World Forum for Harmonization of Vehicle Regulations

Proposal for Corrigendum 2 to Revision 5 to UN Regulation No. 14 (Safety-belt anchorages)

Corrigendum 2 to Revision 5 to UN Regulation No. 14 (Safety-belt anchorages)

Figure 1, correct to read:

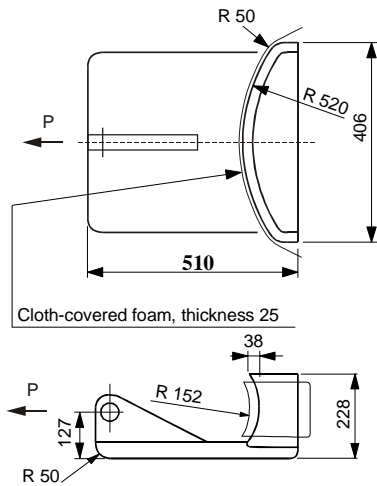
Annex 5,
